STATE OF CONNECTICUT  
CONNECTICUT SITING COUNCIL

IN RE: :  
: :  
A PETITION OF CELLCO PARTNERSHIP : PETITION NO. 1280  
D/B/A VERIZON WIRELESS FOR A :  
DECLARATORY RULING ON THE NEED :  
TO OBTAIN A SITING COUNCIL :  
CERTIFICATE FOR THE INSTALLATION :  
OF A WIRELESS TELECOMMUNICATIONS :  
FACILITY AT 35-37 DANBURY ROAD, :  
RIDGEFIELD, CONNECTICUT : JANUARY 5, 2017

**RESPONSES OF CELLCO PARTNERSHIP D/B/A VERIZON WIRELESS  
TO CONNECTICUT SITING COUNCIL INTERROGATORIES**

SHEET NUMBER  
T-1

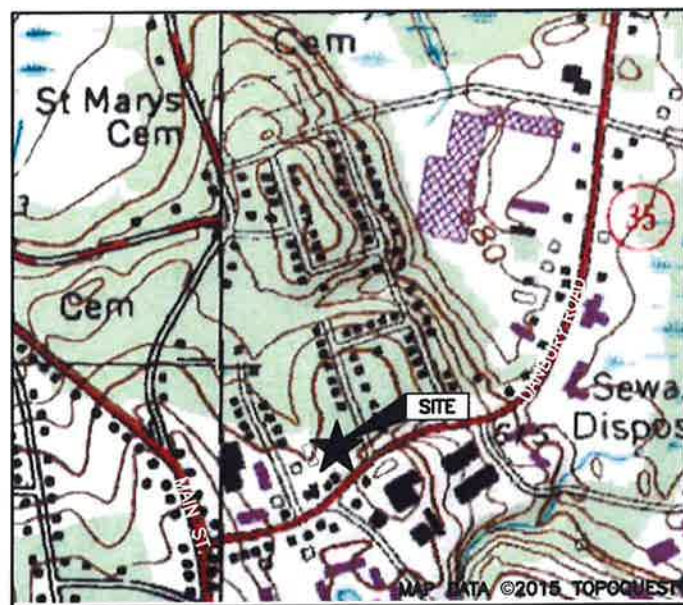
Are the longitude and latitude coordinates noted on Title Sheet T-1 correct, or do they refer to a different building located immediately to the south and closer to Route 35? Please explain and correct Sheet T-1 if necessary.

Included in Attachment 2 is a revised set of project plans including the correct site coordinates from the revised FAA Analysis (Sheet T-1).

SHEET NUMBER  
**C-2**

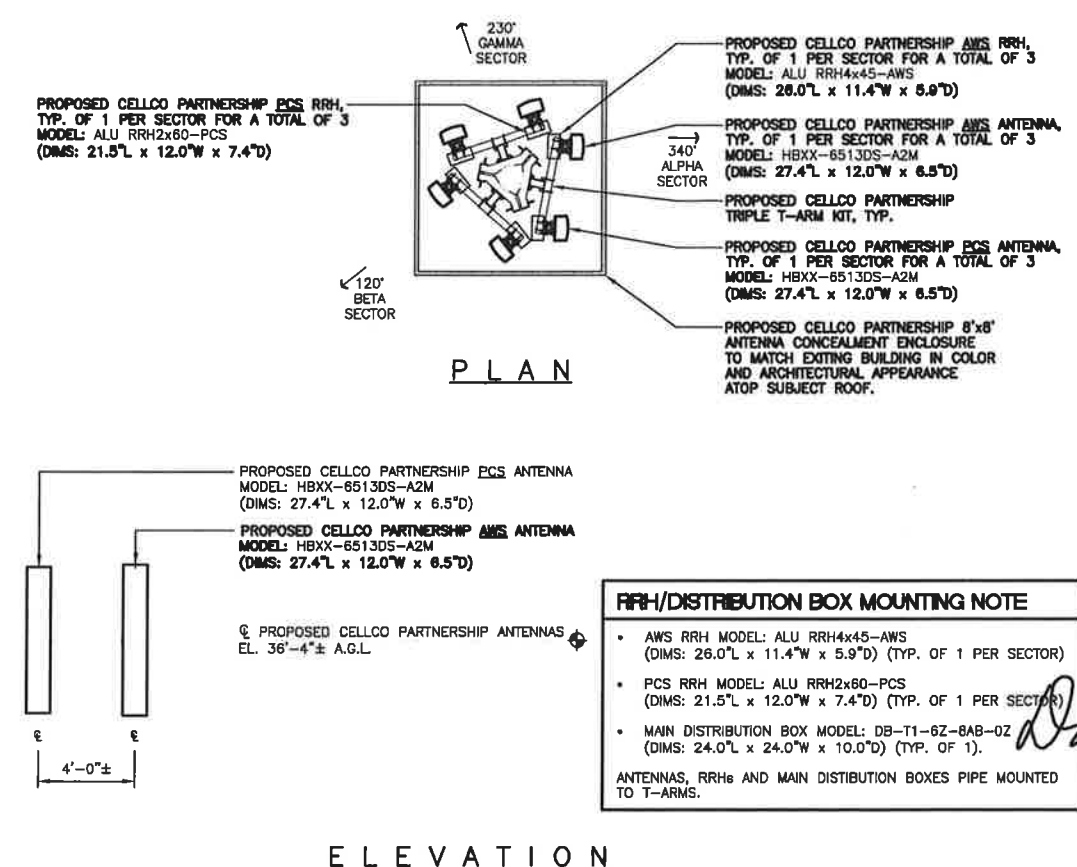
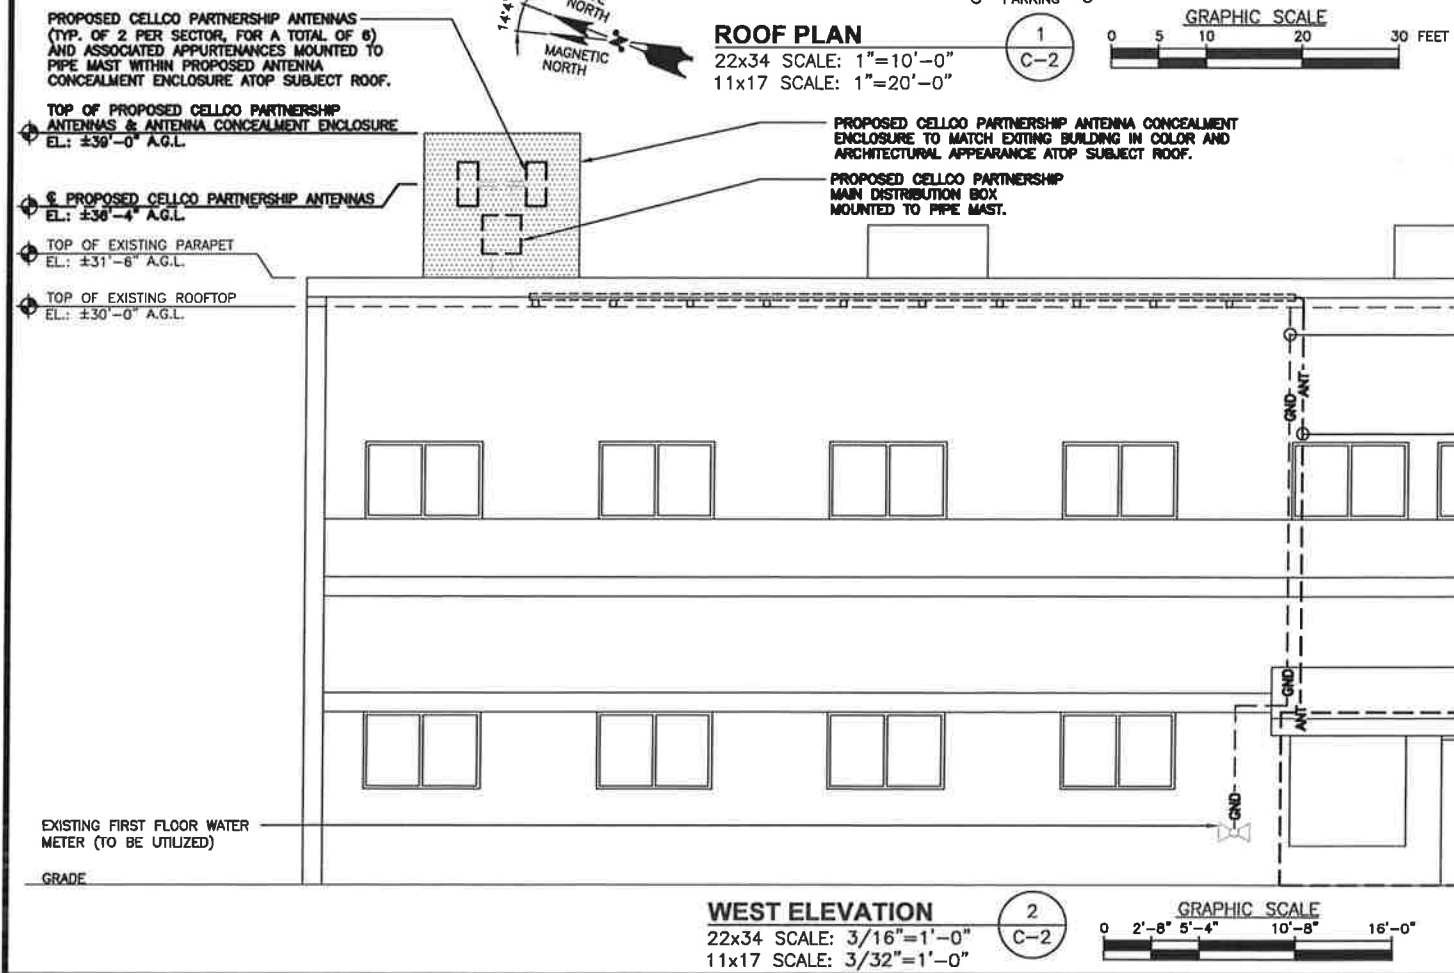
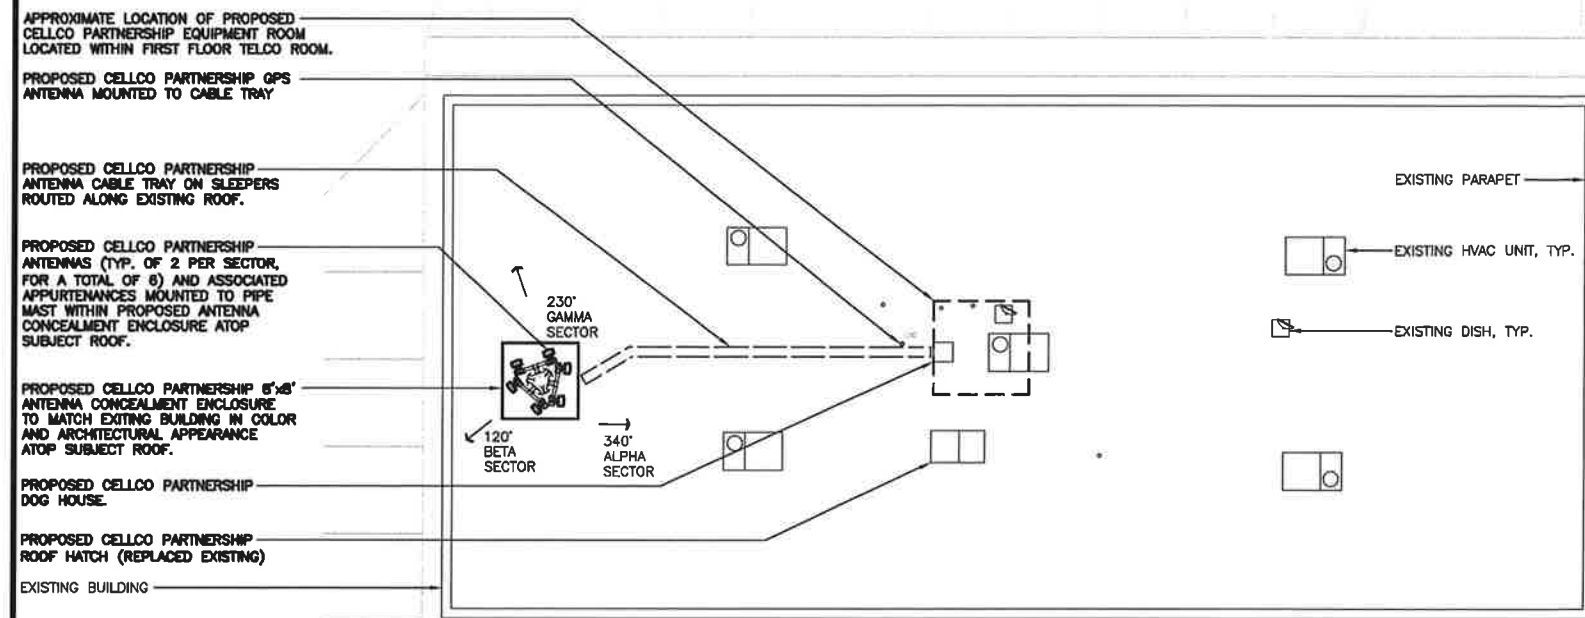
Would the stealth wireless facility be located on the southern portion of the roof (per Sheet C-2 – Roof Plan) as opposed the northern portion of the roof as indicated by the “Proposed Panel and Associated Appurtenances...” callout on the aerial “Site Schematic?” Please explain and provide a revised Site Schematic if necessary.

The roof-top tower and screening enclosure will be located in the northerly portion of the roof as indicated on the Site Schematic included in the Petition filing. The revised project plans included in Attachment 2 are now consistent with the Site Schematic and show the tower and screening structure in the northerly portion of the roof. (See Sheet C-2 – Correction to north arrow for the roof plan and West Elevation reference).
